9.1 NO. 4 (LOT: 1; S/P: 24447) PRIMROSE STREET, PERTH - PROPOSED ALTERATIONS AND ADDITIONS TO GROUPED DWELLING

EXECUTIVE SUMMARY:

PLANS
 PROPOSED GROUND & FIRST FLOOR

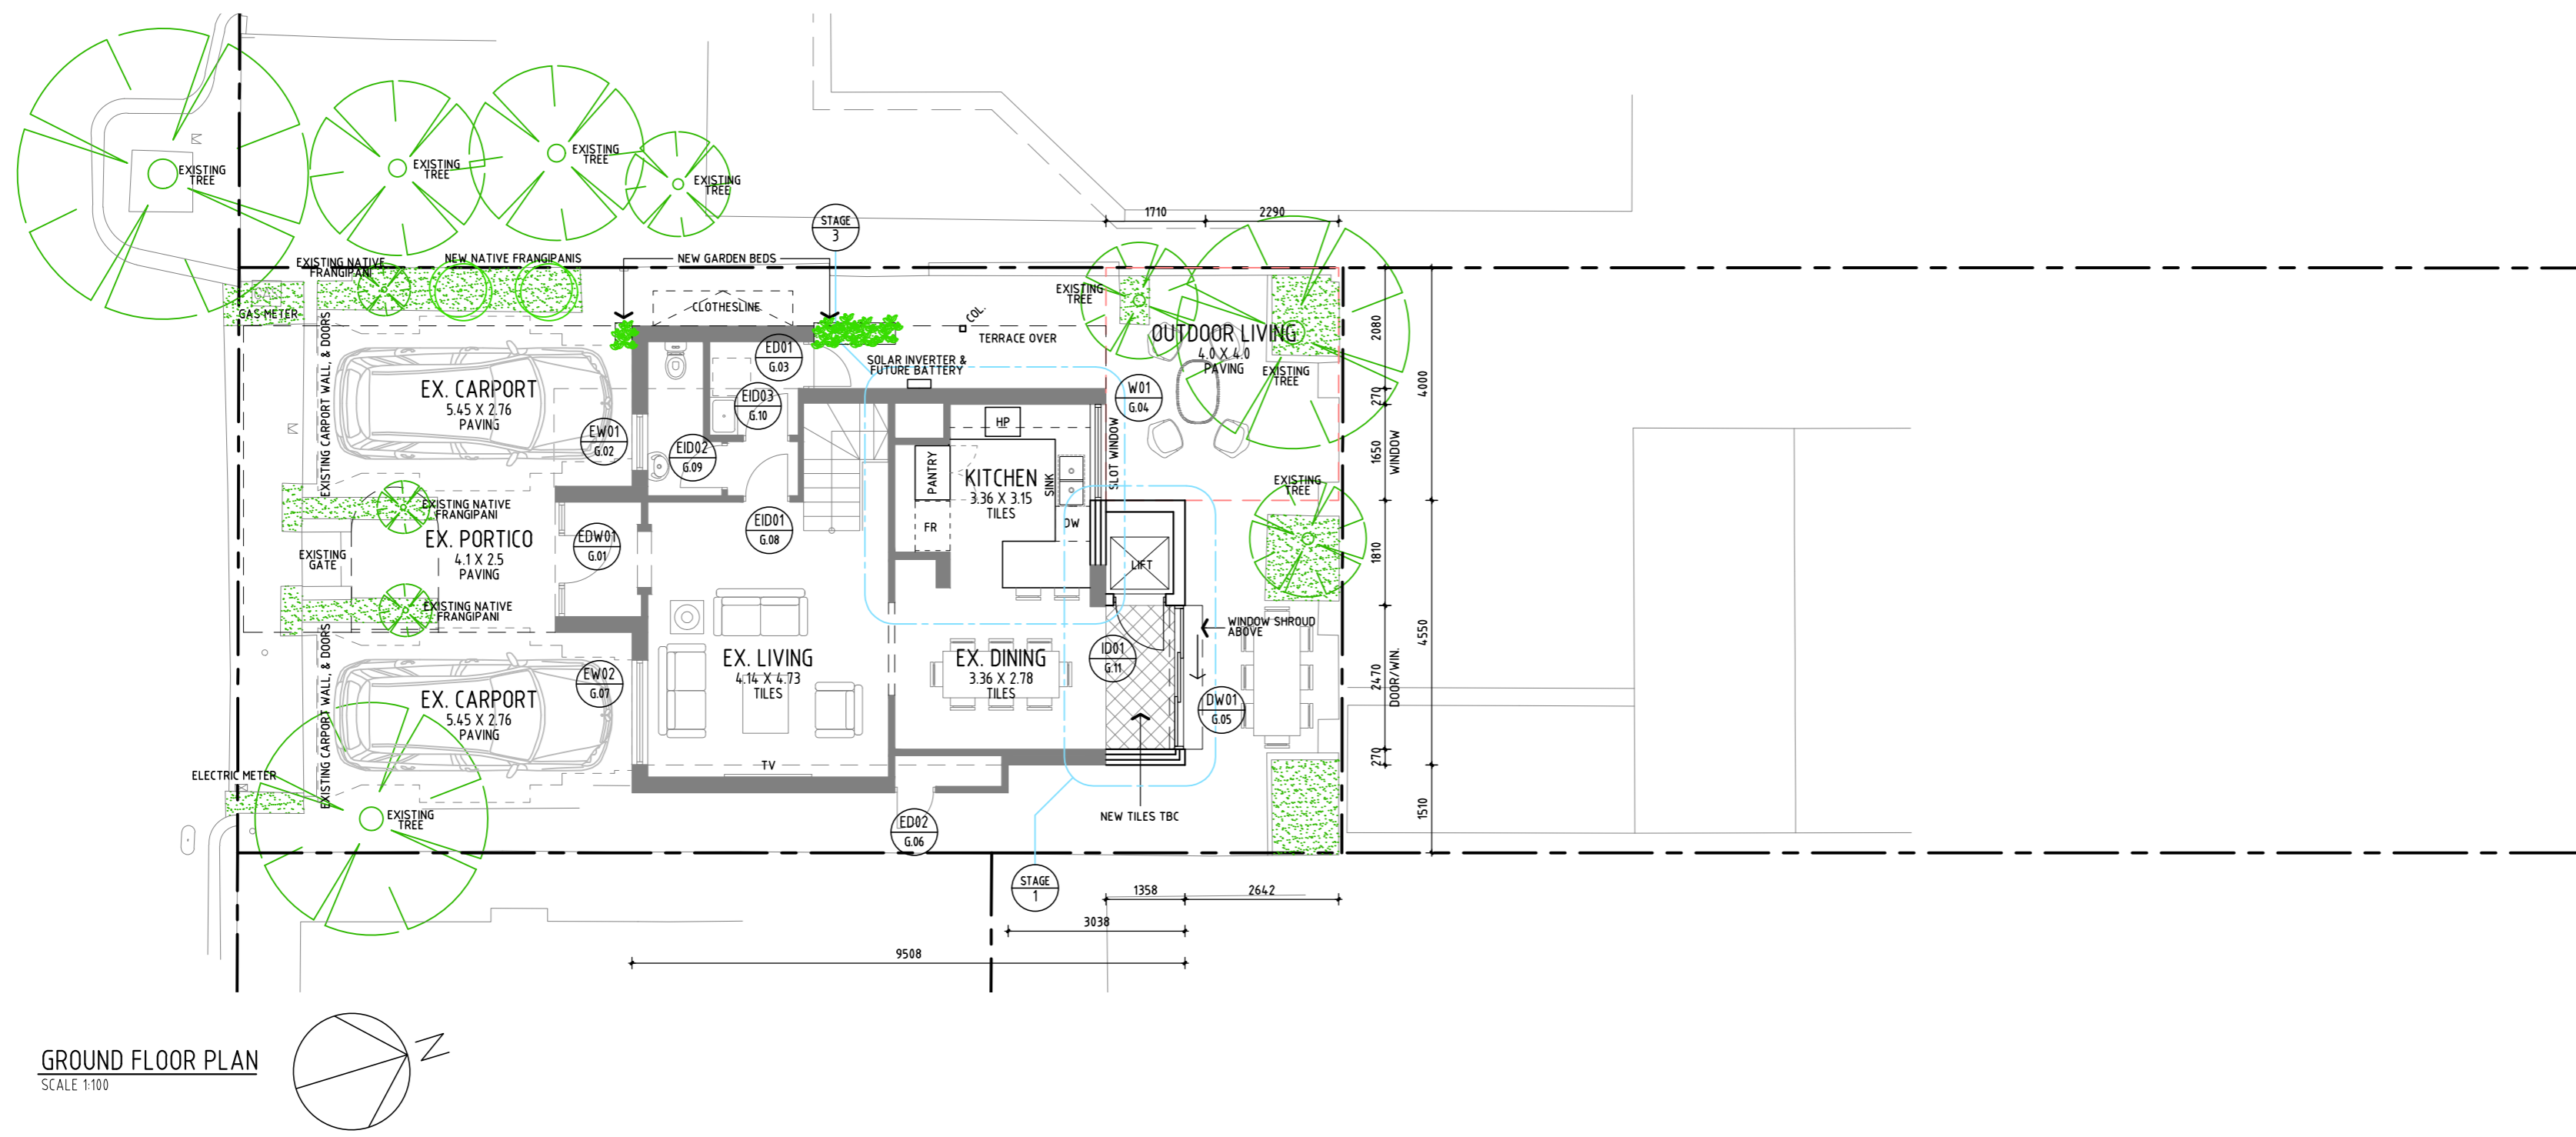
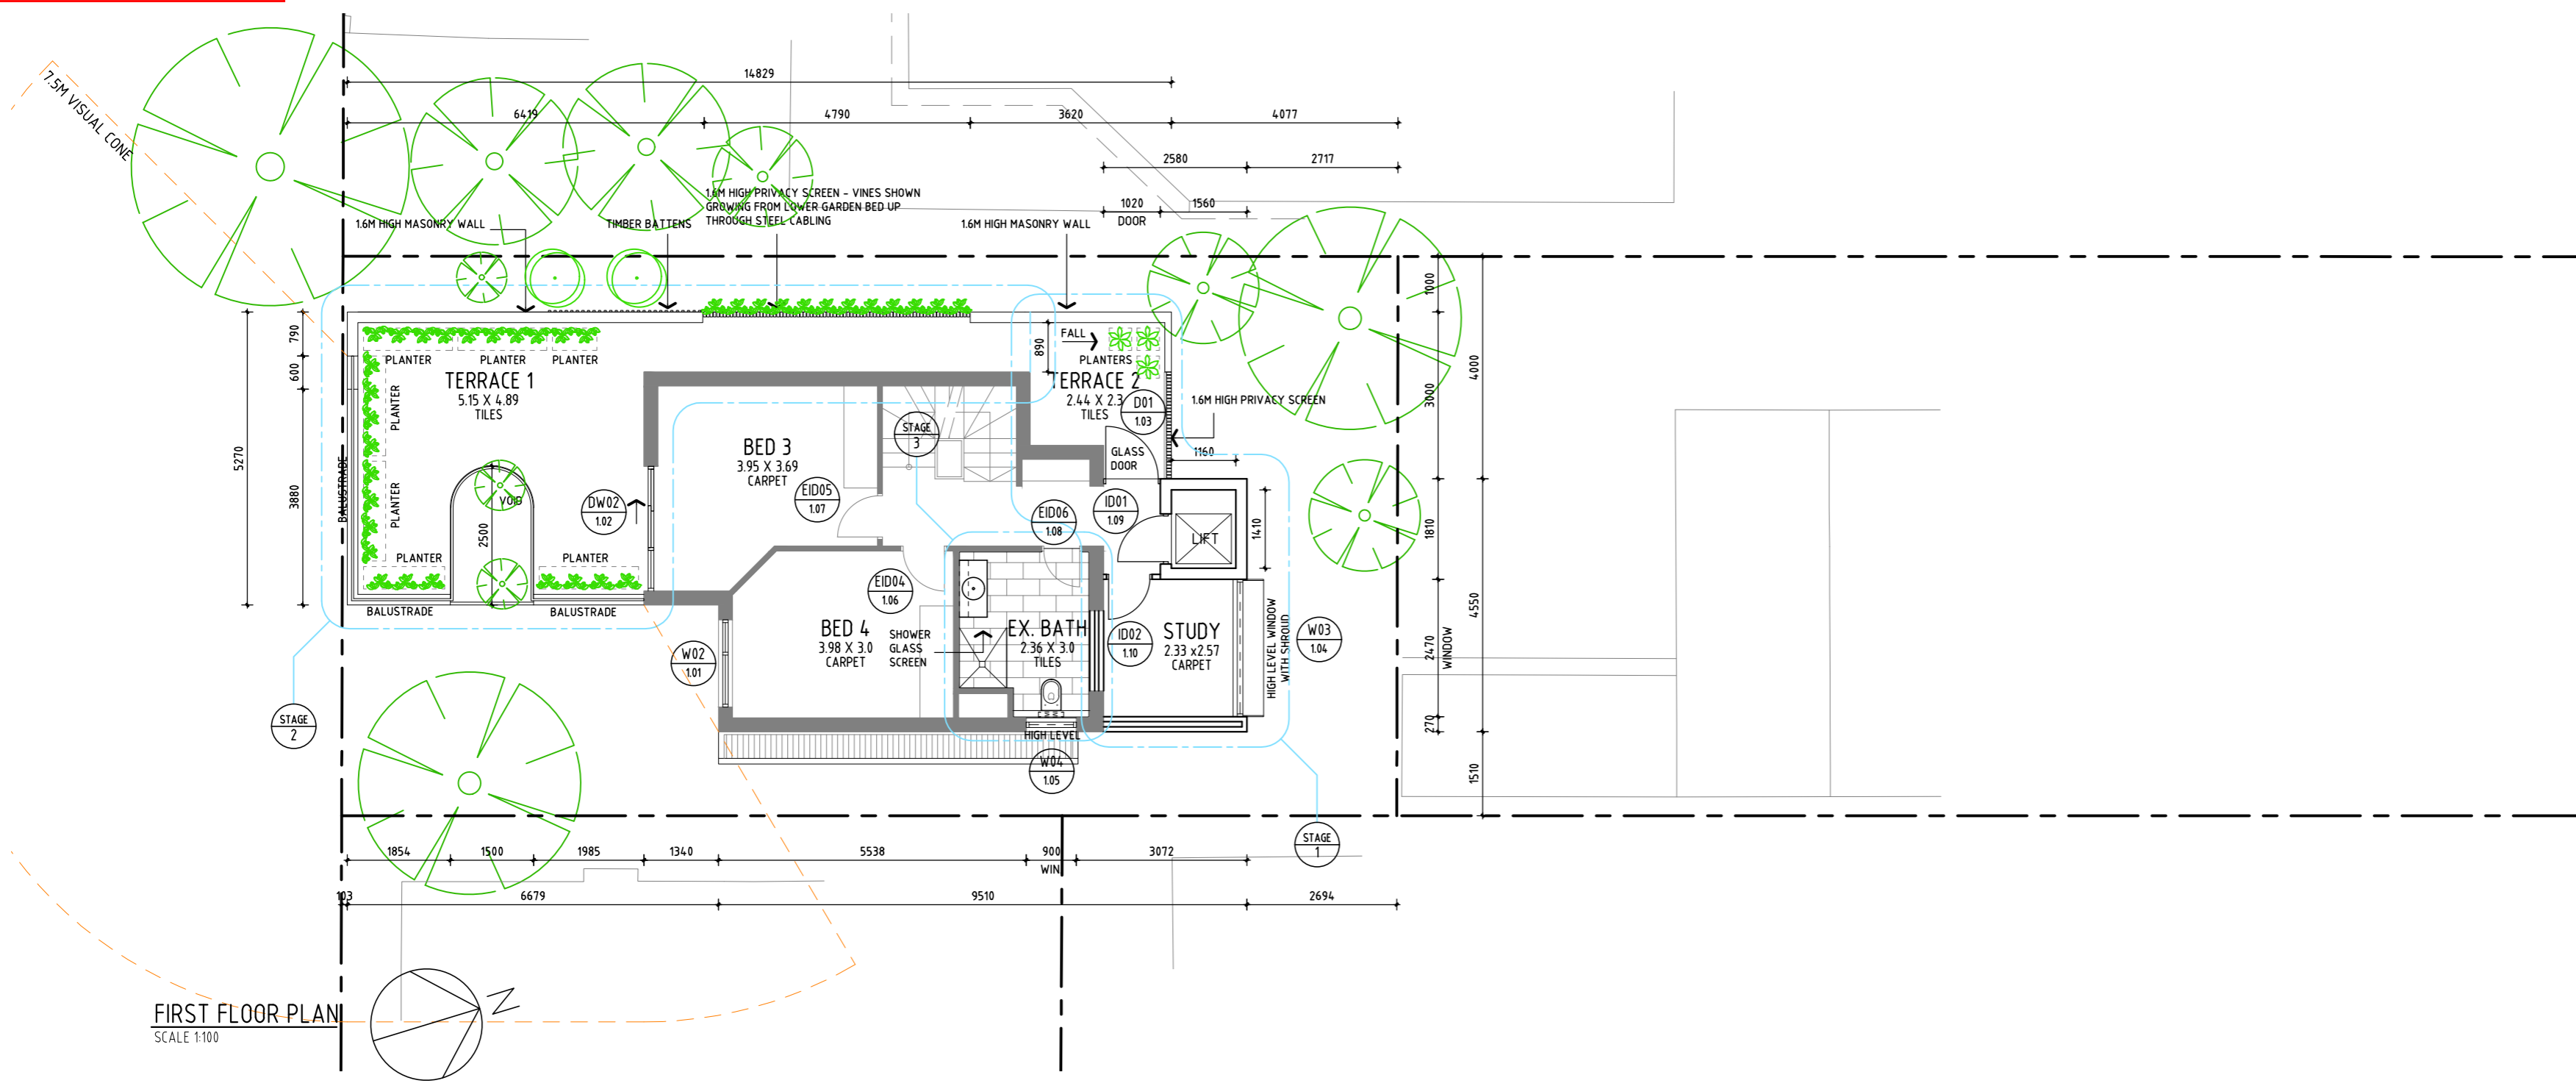
- Built Form and Scale – Visual privacy to the east from the terrace is still non-compliant. The justification notes a Frangipani tree which is a deciduous tree and therefore doesn't assist with this during some times of the year. It is acknowledged the terrace may look onto a three storey solid wall however visual privacy also needs to be considered in relation for the potential for adjoining sites to be redeveloped in the future. The recommendation to achieve green in Built Form and Scale is to make overlooking of the east property from the terrace compliant with screening given this is easy to achieve and the terrace can still achieve an outlook to the south over the laneway.

In response to the 29 March 2023 DRP Chairperson comments, the applicant proposed the addition of on structure planting along the eastern edge of the terrace.

- The inclusion of additional on structure planters provides sufficient screening to the adjoining eastern lot.
- It is noted that the previously provided requests for modifications to the Primrose Street frontage have not been implemented. Due to the ground floor façade (garage and front door) being retained as existing, the applicant has limited opportunity to further improve the legibility of the dwelling. As such, the proposed and existing legibility of the proposed development is supported.

5.3 The landscaping installed to the planter boxes to the eastern edge of Terrace 1 shall be to a minimum height of 1.6 metres above the finished floor level to ensure compliance with the visual privacy requirements of the Residential Design Codes and thereafter maintained, to the satisfaction of the City; and

WEST ELEVATION
SCALE 1:100

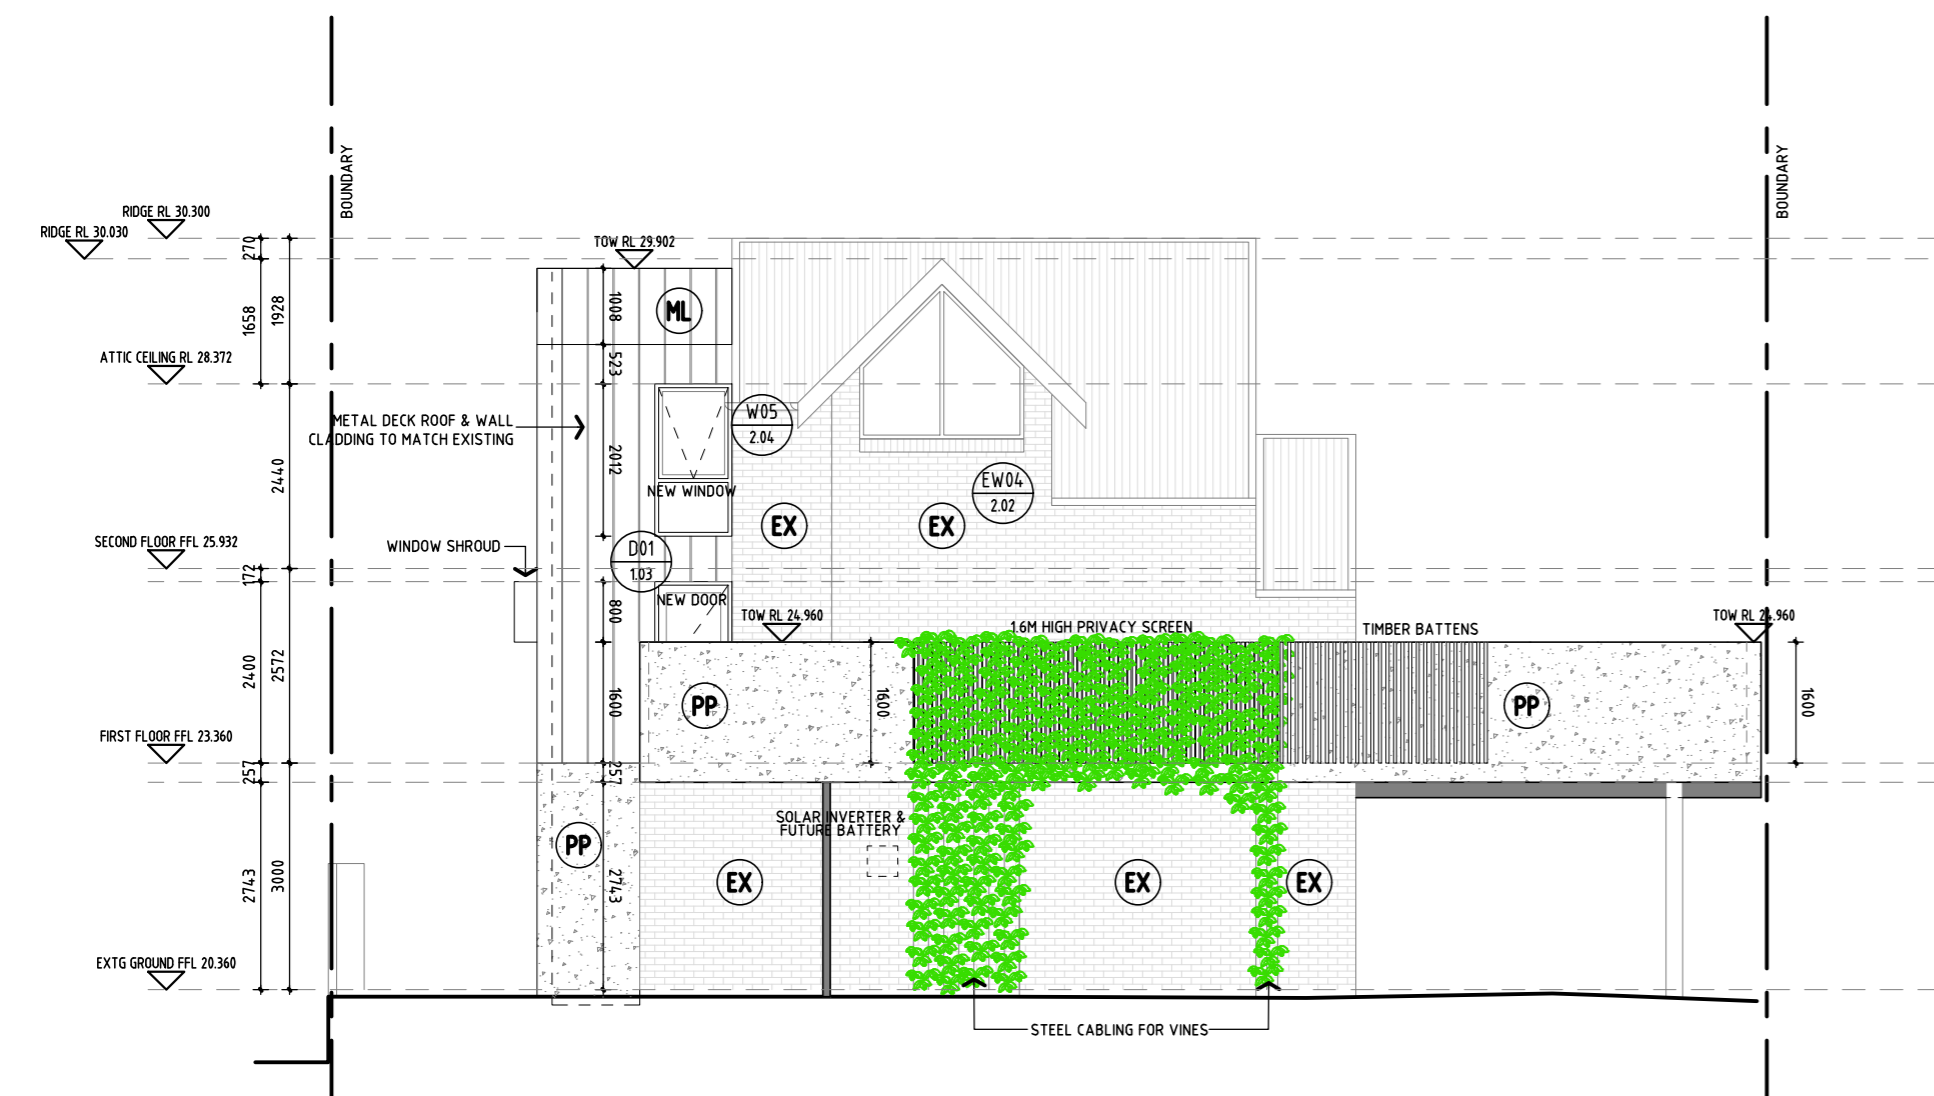
- 1.6 metres privacy screening was extended along the entire western boundary of the terrace to reduce all overlooking.
- Garden beds have been introduced below and cables introduced for vines to be planted at the ground level. It is proposed that the vines will grow up and into the privacy screen.
- Composite timber battens to be affixed to a section of wall adjacent to the privacy screen for design articulation.
- Two additional Native Frangipani trees (*Hymenosporum Flavum*) are to be planted along the western boundary to add softening to this interface.

In accordance with the Built Form Policy and R Codes, the deemed-to-comply lot boundary setback is 1.7 metres from the western lot boundary. The proposed terrace provides a 1.0 metre setback from the western lot boundary.

The walkway connection between the terraces provides access via the northern lift/hall lobby area without going through the bedroom/study, which is very important for the Owners, and not negotiable. A privacy screen matching the screen proposed to the northern roof terrace has been adopted to the section of walkway joining the front and rear terraces. This will be in the form of metalwork and minimum 75% obscured, to 1.6m height. Garden beds have been introduced below and cables introduced for vines to be planted at the ground level. It is proposed that the vines will grow up and into the privacy screen, adding a green-wall effect, breaking up the bulk of the wall at mid-length and adding softness and articulation to this elevation.

Composite timber 40 x 30mm battens, 'Saltbush' colour (grey-brown) will be affixed to the wall to a section adjacent the privacy screen to add further softening and articulation to the wall as indicated on the drawings.
